# M25 junction 10/A3 Wisley interchange TR010030 5.5 Flood risk assessment

### 5.5 FLOOD RISK ASSESSMENT

<b>Regulation Number:</b>	Regulation 5(2)(a)
<b>Planning Inspectorate Scheme Reference</b>	TR010030
<b>Application Document Reference</b>	TR010030/APP/5.5
<b>Author:</b>	M25 junction 10/A3 Wisley interchange project team, Highways England

Figure 3: Cross section data showing out of bank flows

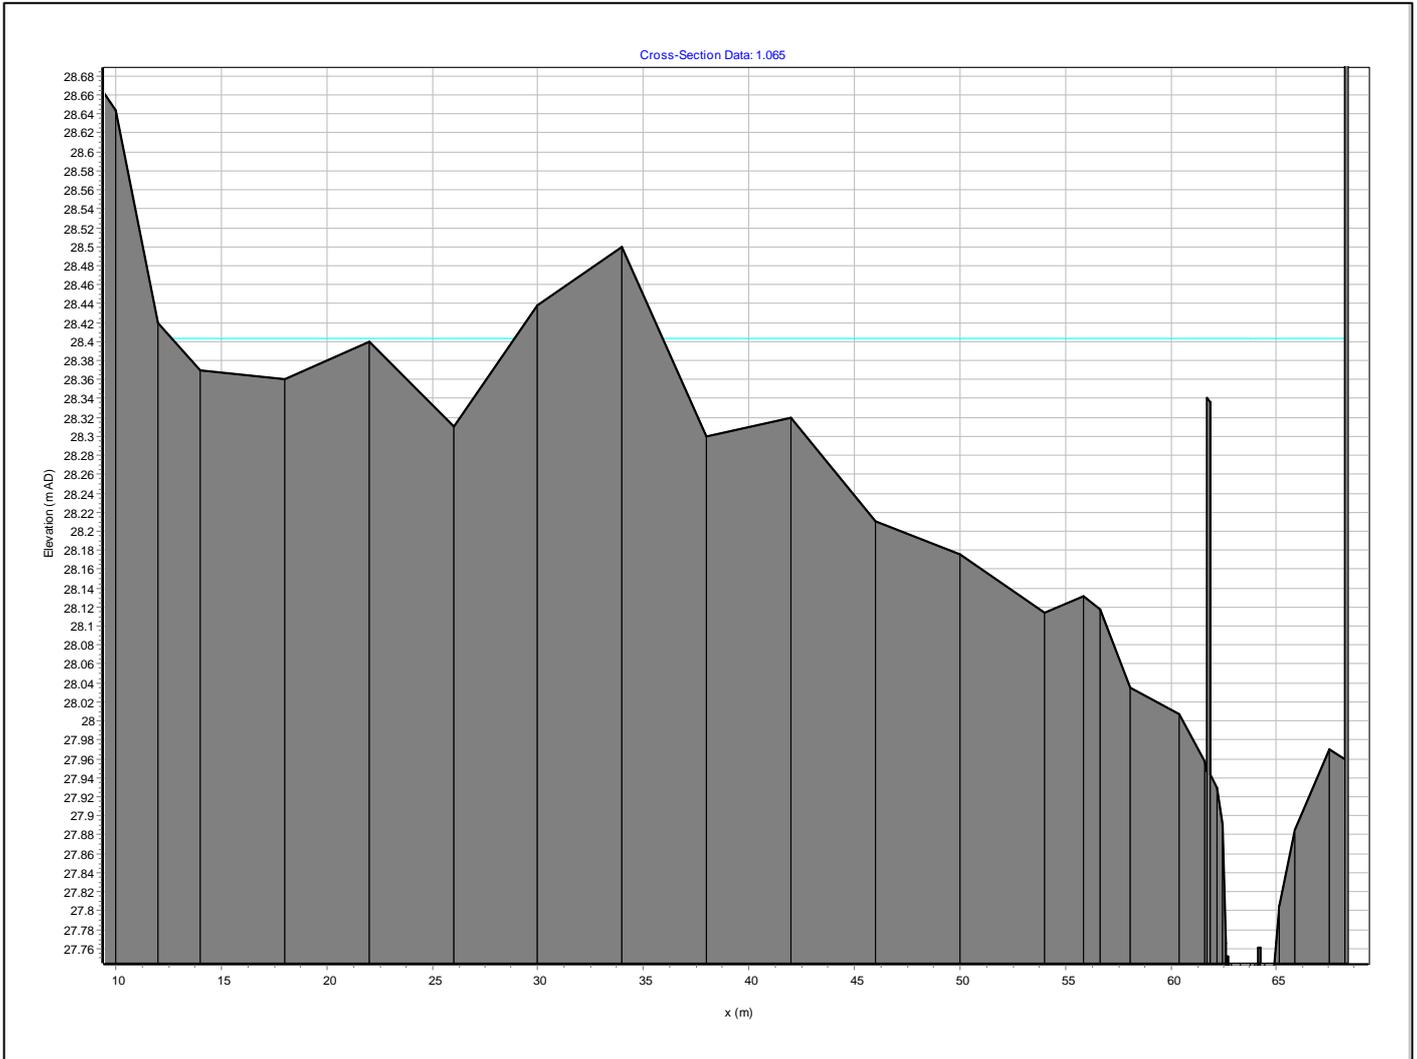
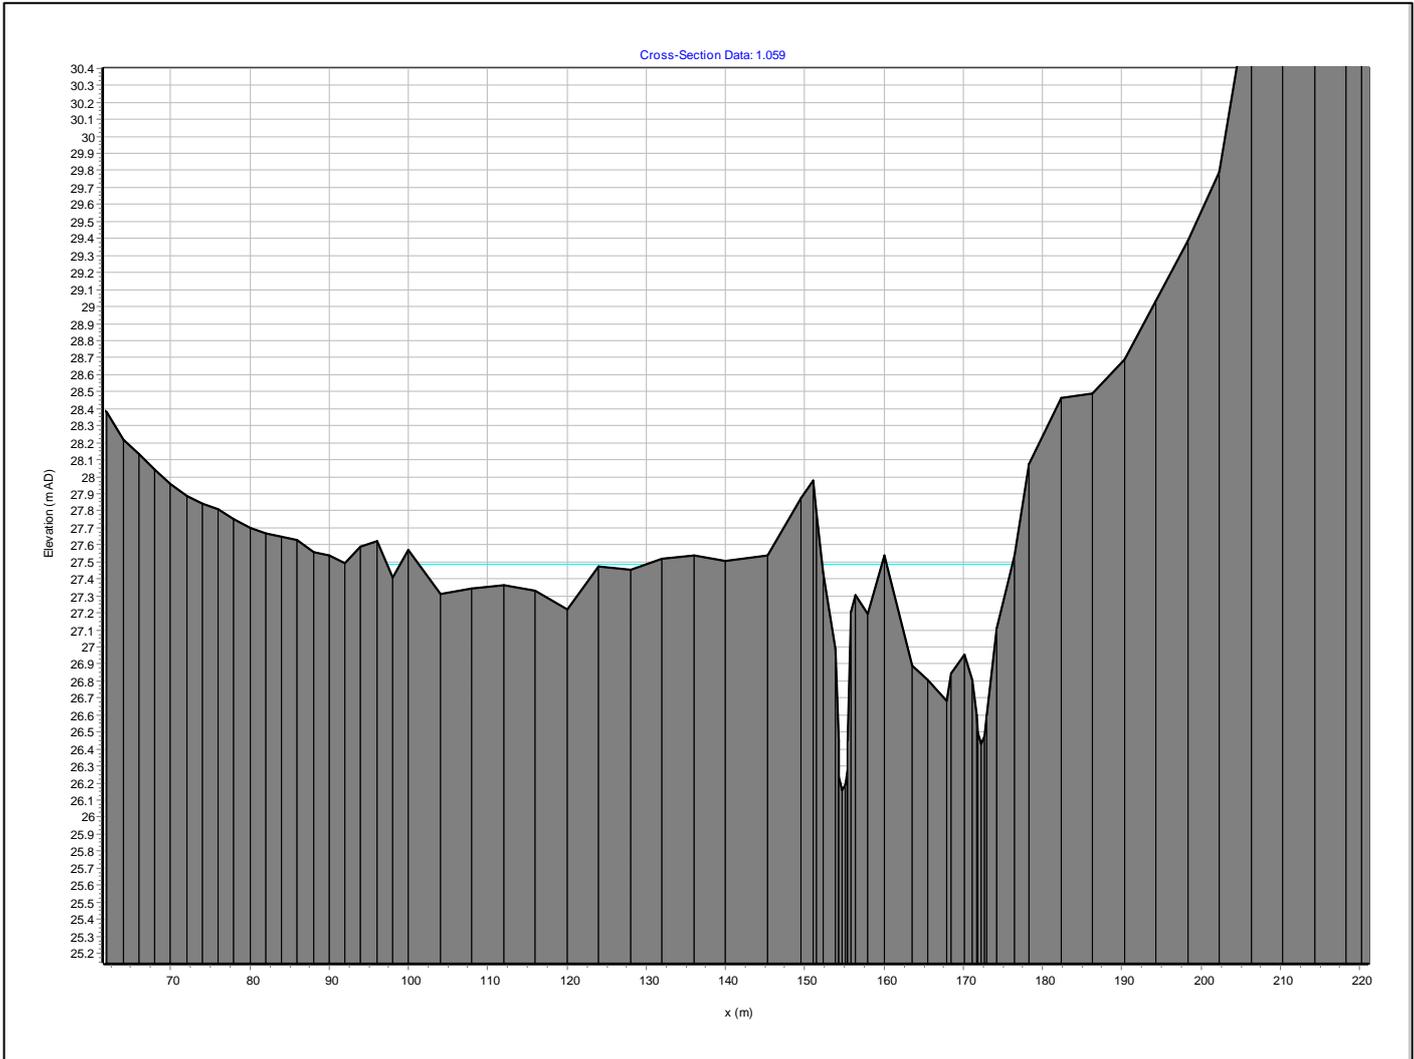
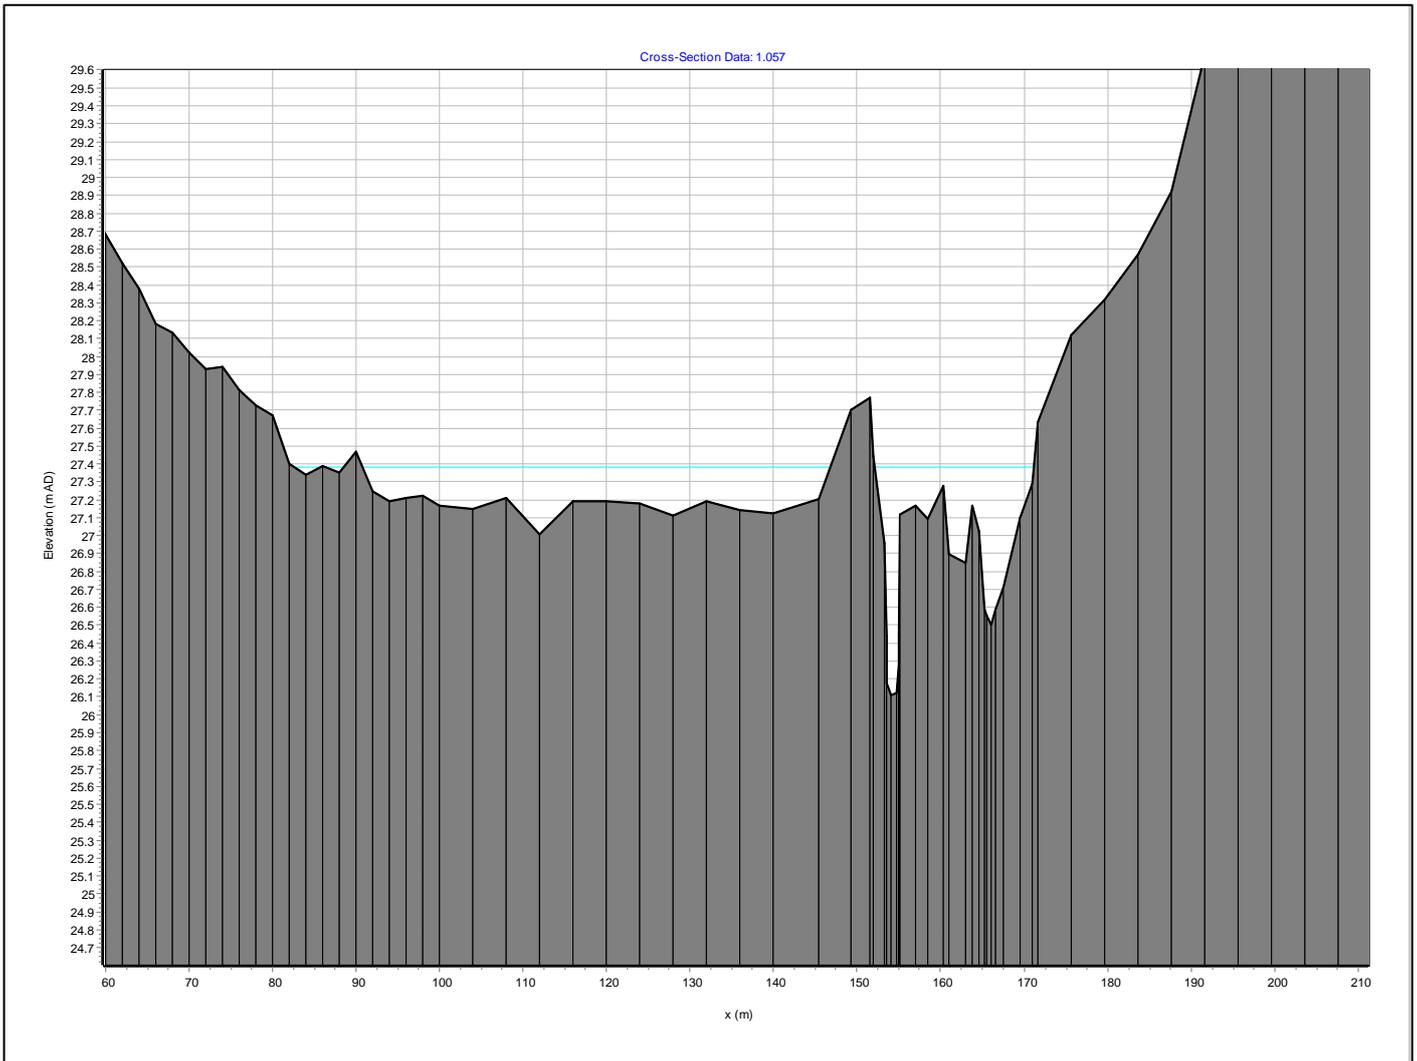
you if necessary.	
Does conveyance look appropriate? <i>Do channel conveyance values vary outside the ratios of 0.7 and 1.4 between adjacent river sections? (Are panel markers needed or in the correct place)</i>	There are massive variances in channel conveyance- the first 7 sections have conveyance values of 18,000, 400, 210, 12,000, 18,000, 35,000 and 240,000m <sup>3</sup> /s. These represent ratios of 0.022, 0.525, 57, 1.5, 1.94 and 6.8 respectively.	Review and amend cross section data to reflect true size of channel.	Values quoted are for conveyance at the maximum cross section elevation which differs significantly between cross sections and therefore comparison of these values is inappropriate. The conveyance at the same relative level within adjacent sections is generally within the usual variation. No updates to the model have been made.	Agreed- however this is not good practise
Bank Markers. Are they used and if so, are they suitably located?	Yes	n/a	n/a	n/a

Figure 4: Extract from Bridge drawing

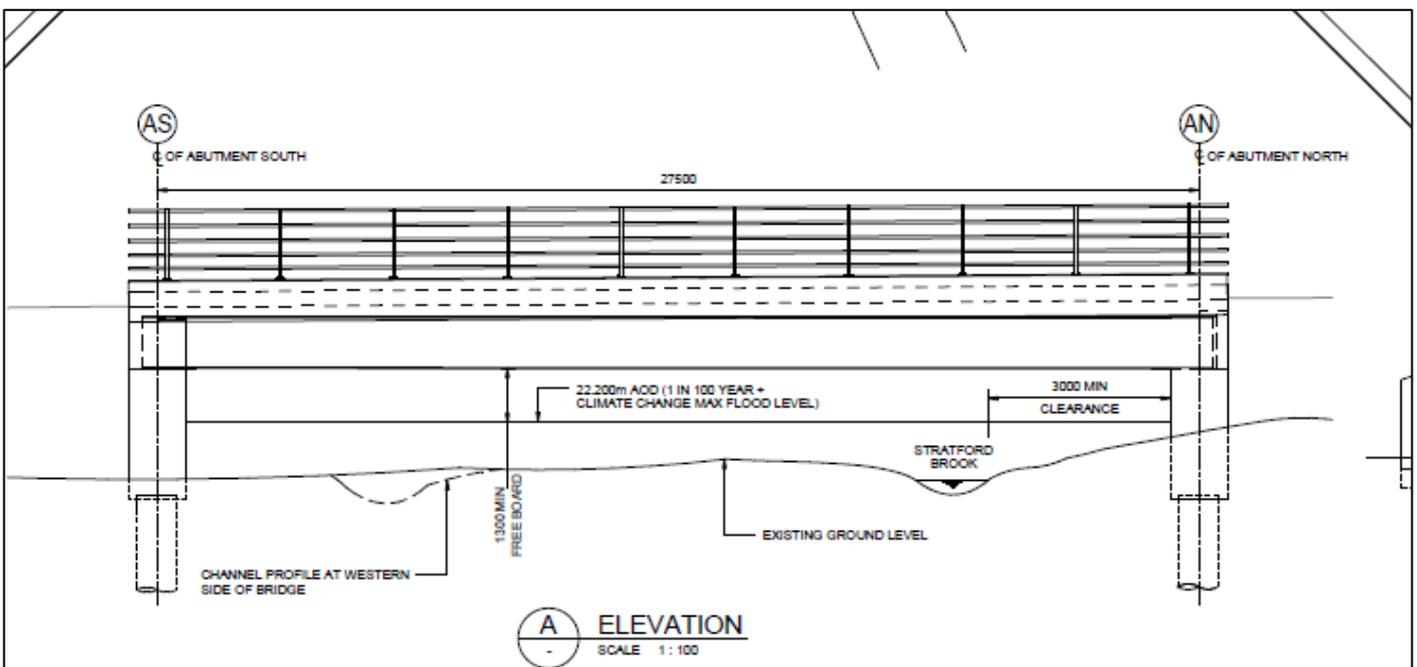
STRUCTURES				
Item Checked	Comments	Actions	Atkins Response	M+F Response
Are all structures represented? If not have explanations for structures not modelled been given in the Log/report? <i>If more than 10 structures, check of 10 most critical structures required only.</i>	All existing structures appear to have been modelled appropriately. There is some confusion over the level of the soffit and the alignment of the proposed bridge. The modelled soffit level is shown as 23.24mAOD however the drawing (see Figure 4) shows a level of 23.5mAOD, which is defined as 1300mm above the 1:100yr+CC level given	Clarify level of proposed bridge soffit. Check against surveyed channel profile at bridge as the drawing and the model data differ greatly, the drawing suggests a secondary channel within the span of the bridge which is not modelled but could be significant.	The report (section 2.3) states that the level defined on the drawing has been superseded. The channel cross section on the drawing is indicative and should not be interpreted as anything other than that.	Noted- as this bridge soffit would not affect the 1:100yr +35% this should not be an issue.

as 22.2mAOD which does not correspond itself to modelled levels extracted from the results. The alignment of the bridge and the channel profile at the bridge should be not well defined between the model data and drawings.		It is not a secondary channel. As labelled on the drawing it is the lateral location of the same channel at the downstream end of the proposed bridge. No changes to the model have been made.	
Are invert levels correct compared to survey data? <i>Check of all critical structures required.</i>	No survey has been provided to check against.	Supply survey to check structures against	The survey data used is as provided by the EA. We can send the survey back to you if necessary.	Noted
Do bridges surcharge? If so has orifice flow been enabled?	Orifice flow is not enabled however the bridges are modelled appropriately with spill units to take surcharging flows.	n/a	n/a	n/a
Are there spills around the structure or over the top represented appropriately? <i>– these could be in 1d or 2D, if a linked model.</i>	No reporting or comments detail the nature of the spill data.	For Bridges where spills are active for the 1:100yr+CC event- report what the spill unit defines or add comment to model.	Report updated to define the use of spill units.	Text added to 2.4.3

Figure 5: Convergence plot from re-run of the 1:100yr+CC simulation

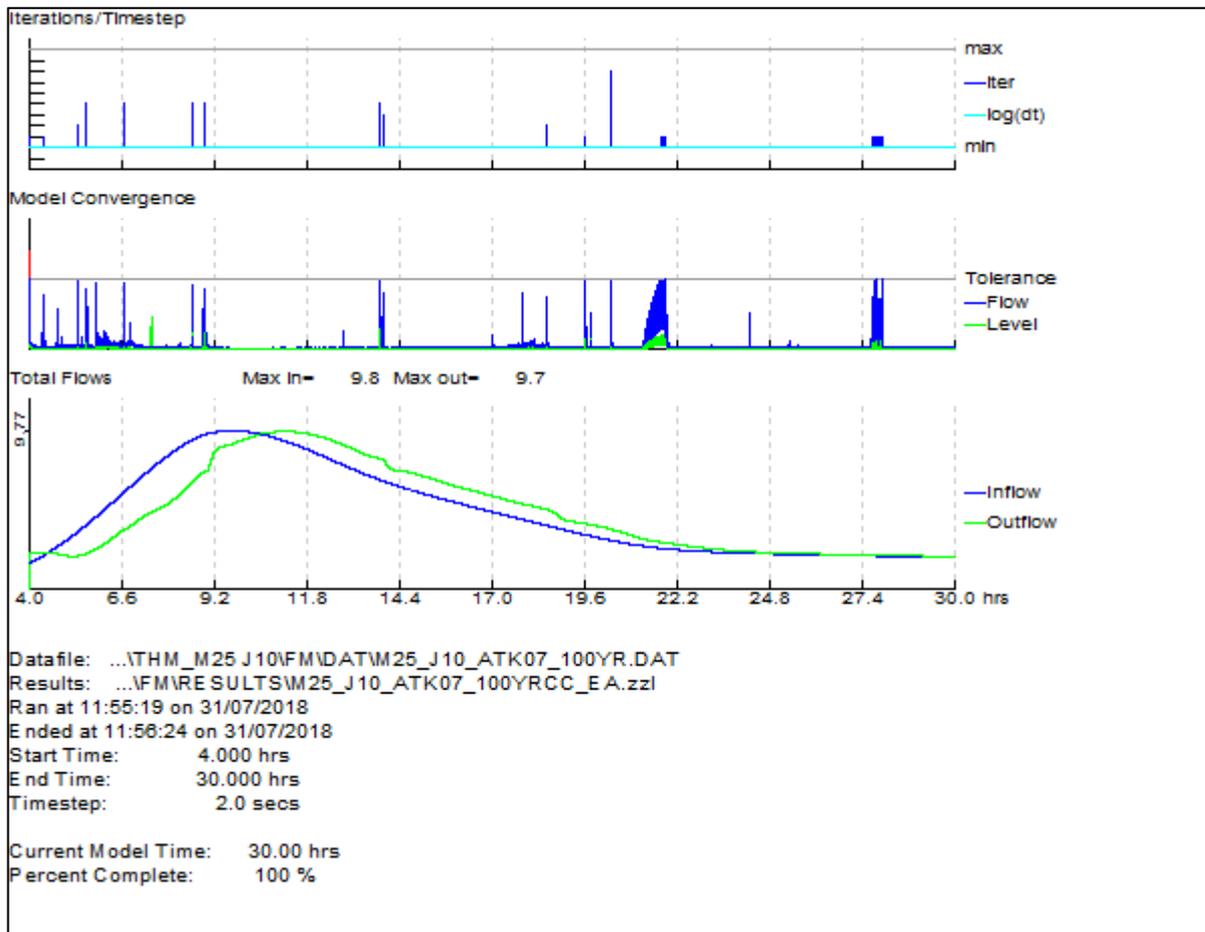
Item Checked	Comments	Actions	Atkins Response	M+F Response
Mass Balance	Mass balance reported in the .ZZD file shows MB is 0.81% of peak system volume, and 0.08% of the boundary inflow volume. These values are fine.	n/a	n/a	n/a
Convergence <i>Check zzd file and bitmaps</i>	Convergence plots look fine (See Figure 5 below)	n/a	n/a	n/a
